Technical Service Bulletin

40 Rumbling/creaking noises from front of the vehicle when driving - Q7, Q8, A8

40 22 40 2058489/4 April 26, 2022. Supersedes Technical Service Bulletin Group 40 number 21-27 dated August 17, 2021, for reasons listed below.

Figure 1. Hydro-bush.

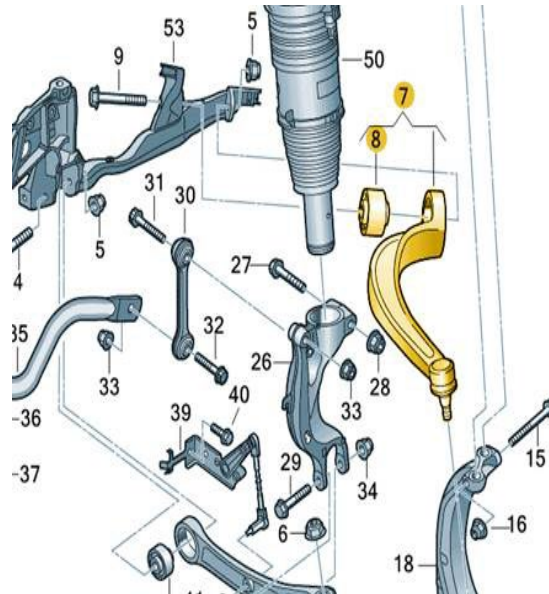
The noises can be generated on the lower-left guide in the area of the hydro-bushing. (Figure 1, Positions 7 and 8).

1. Replace the hydro-bushing on the guide link in pairs (Figure 1, Position 8) according to the instructions in Elsa at Repair Manual, *Chassis >> Suspension, Wheels, Steering >> 40 Front Axle >> Lower Control Arm and Ball Joint >> Guide link bonded rubber bushing, Removing and Installing.*

3. If repeat repairs are necessary and the hydro-bushing has already been replaced (pressed out/in), the complete guide link has to be replaced (Figure 1, Position 7) in Elsa at Repair Manual, *Chassis >> Suspension, Wheels, Steering >> 40 Front Axle >> Lower Control Arm and Ball Joint >> Guide Link, Removing and Installing.*

Figure 2. Coupling rod.

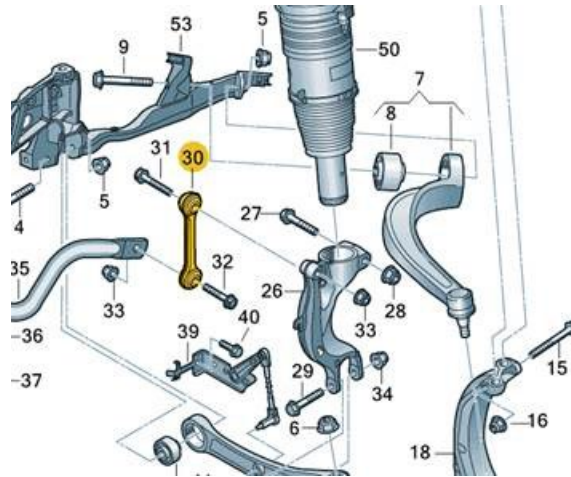
Parts such as the coupling rod (Figure 2, Position 30) are usually replaced by mistake, presenting no problems.
